City of Portland, Maine – Building or Use Permit Application 389 Congress Street, 04101, Tel: (207) 874-8703, FAX: 874-8716

BUILDING PERMIT REPORT

DATE: 30 July 99 ADDRESS: 100 Commercial ST. CBL: 030-C-001
 REASON FOR PERMIT: Interior renovations
 BUILDING OWNER: Soley Wharf LLL
 PERMIT APPLICANT: _____ / Contractor Monaghan Woodwork Inc.
 USE GROUP B CONSTRUCTION TYPE 3B

HEWING TRAVEL - 1ST FL.

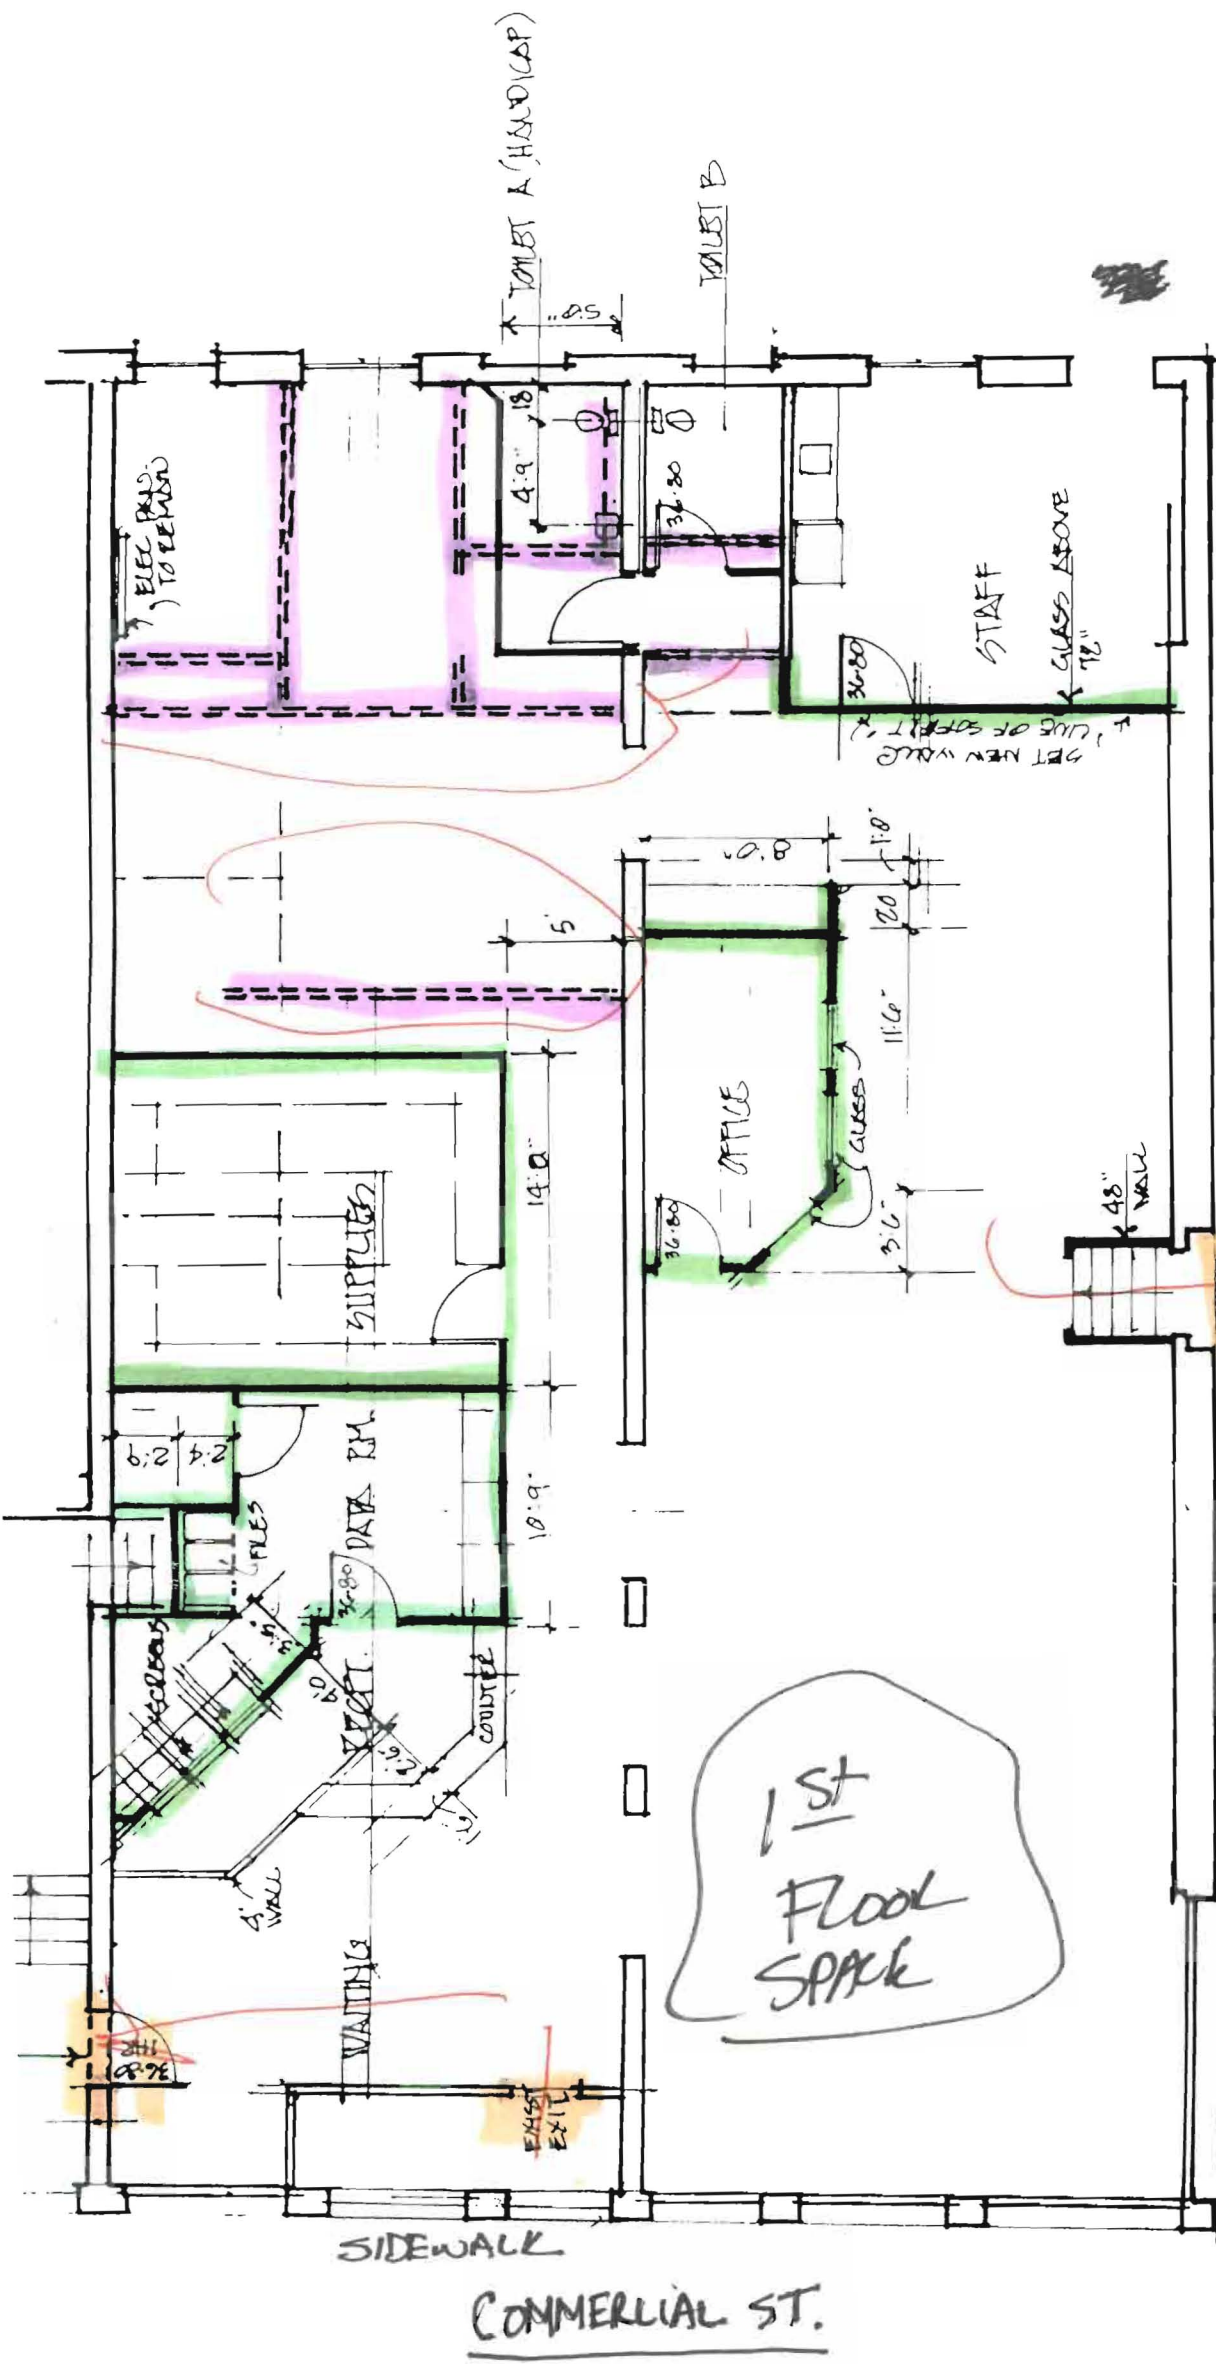
35. *This permit does not authorize the removal of any bearing walls*
- 36.
- 37.
- 38.

****On the basis of plans submitted and conditions placed on these plans any deviations shall require a separate approval.**
